IDAP REPORT – SECTION 4.55(1A) MODIFICATION

Property:	24 Oxford Road STRATHFIELD LOT: A DP: 334827 DA2019.33.4
Proposal:	Section 4.55(1A) Modification Application for internal and external reconfiguration and changes to the façade of an approved dwelling house, removal of the approved secondary dwelling and addition of a cabana & swimming pool.
Applicant:	A Mahendran
Owner:	Mr Ali Ali
Date of lodgement:	27 April 2021
Notification period:	6 May 2021 to 20 May 2021
Submissions received:	Nil
Assessment officer:	G I Choice
Estimated cost of works:	\$1,220,000.00
Zoning:	R2-Low Density Residential - SLEP 2012
Heritage:	No
Flood affected:	No
Is a Clause 4.6 Variation Proposed:	No
RECOMMENDATION OF OFFICER:	Approval

Figure 7: Proposed first floor plan

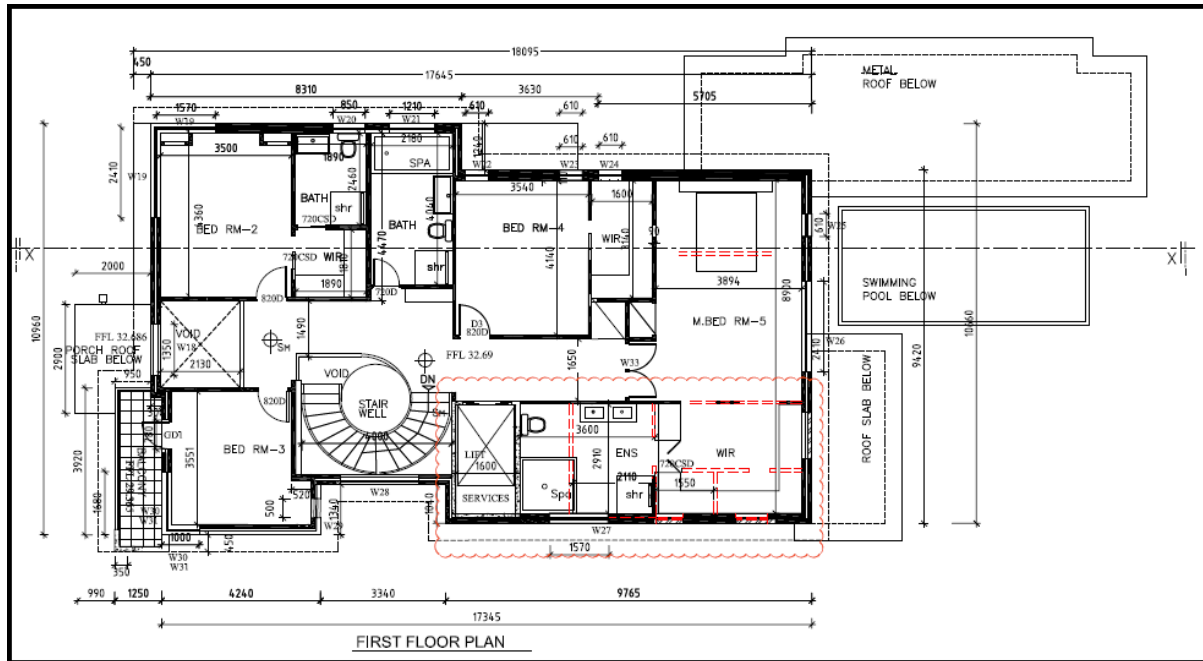
- i) Windows W25 and W26 on the north-eastern elevation and W32 on the south-western elevation on the first floor depicted on Sheet No. A-05, First Floor Plan prepared by AMA Associates Sydney shall have a sill height of at least 1.7m above the finished floor level or have fixed, obscure glazing in any part of the windows less than 1.7m above the first floor finished floor level.

Figure 8: Approved DA 2019/33 basement plan (deleted in DA 2019/33/2)

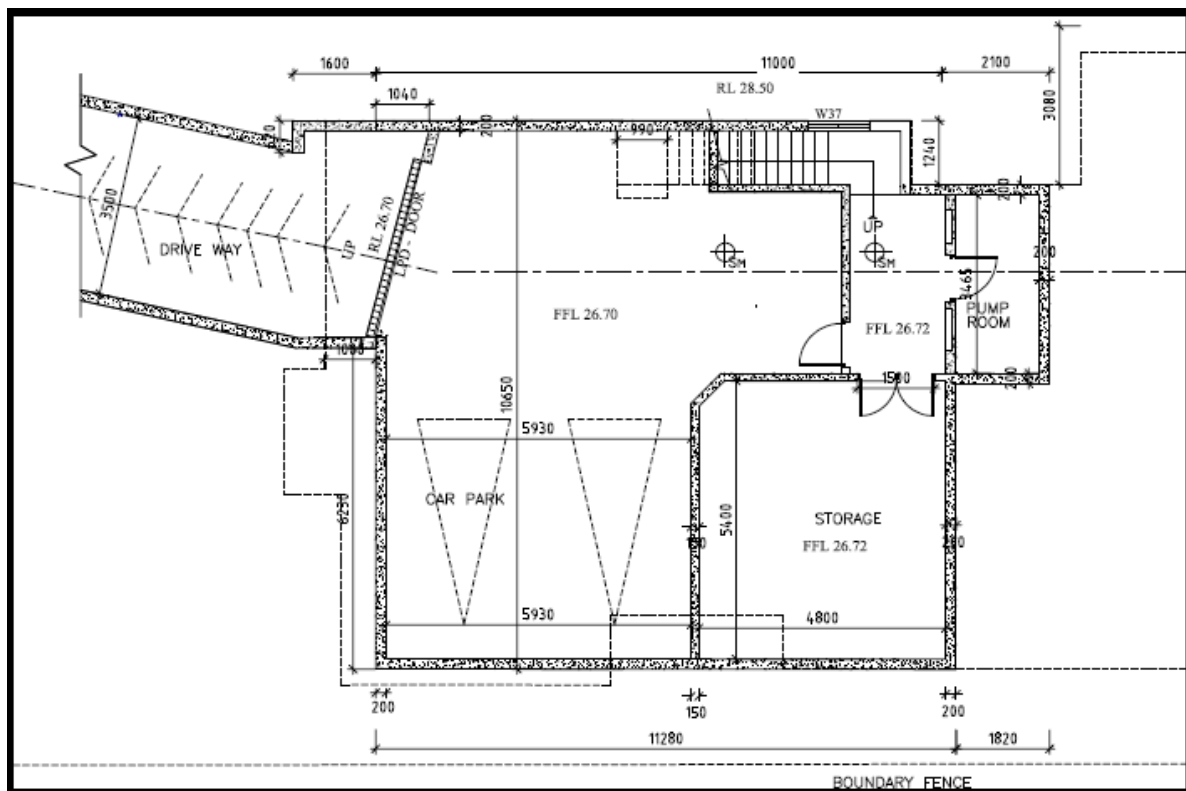
An assessment of the proposed basement plans shows the basement area is not wholly contained within the footprint of the dwelling at ground level as per the Part A 8.2.3.1 requirements of SCDCP 2005. The basement plan has been designed with a minor protrusion beyond the location of the ground floor spiral staircase on the west elevation. It is noted that the proposed basement plan includes a slight increase of the previously approved basement floor area. Minor modifications to the basement design (from previously approved in DA 2019/33) are to facilitate the proposed installation of lift and services area, although the previously approved 25m² storage room has been reduced to 21.6m². In the interest of consistency, an extract from the original DA 2019/33 assessment report is provided below:

The proposed basement plan is considered to be practically the same as previously approved in DA 2019/33 and does not create excessive floor space beyond what is needed for general functionality. On this basis, the minor protrusion is supported.

Figure 11: Proposed north-west & south-west elevations

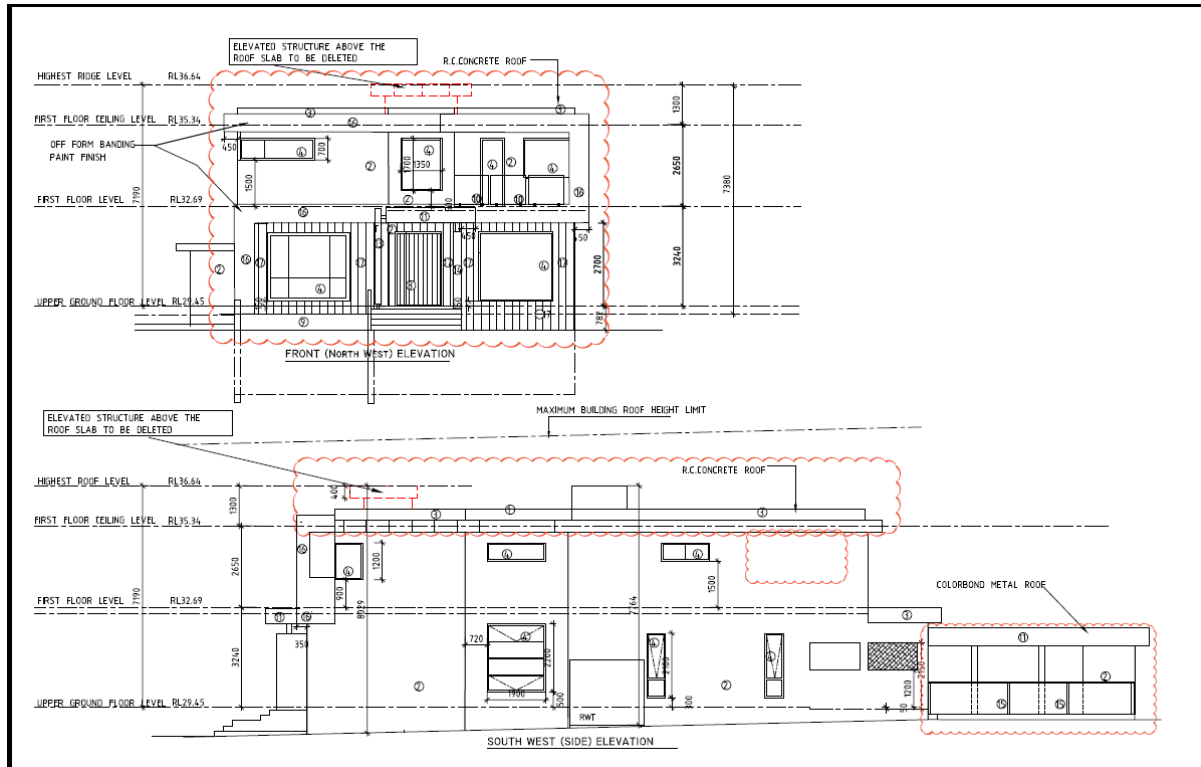
The proposed design change from pitched roof to flat roof is considered acceptable. The roof height at 8m complies with the maximum allowable SLEP height of 9.5m and - at an RL35.9 - will sit comfortably below the ridge heights of 26 Oxford Road (RL 38.2) and 22 Oxford Road (RL 36.9) so as to maintain appropriate transition between adjoining dwellings and minimise visual impacts to the existing streetscape.
